Regulation No. 58 (Rear underrun protection)

Proposal for amendments to Regulation No. 58 (Rear underrun protection)

Submitted by the expert from Germany*

The text reproduced below was produced by the expert from Germany to introduce more stringent requirements for rear underrun protection devices. This proposal supersedes documents ECE/TRANS/WP.29/GRSG/2011/19 and GRSG-102-26. The modifications to the current text of the Regulation are marked in bold for new or strikethrough for deleted characters.

Figure 1

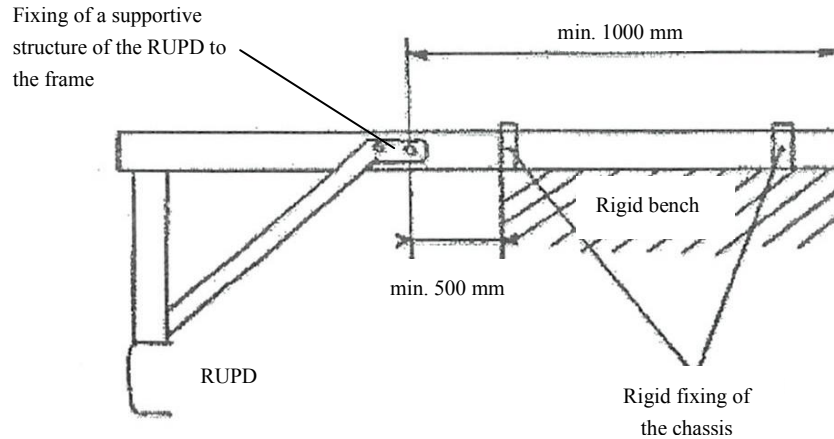
Paragraph 1.1.3., amend to read:

- "1.1.3. On a rigid test bench (see Figure 1, representing the minimum requirements to be fulfilled).
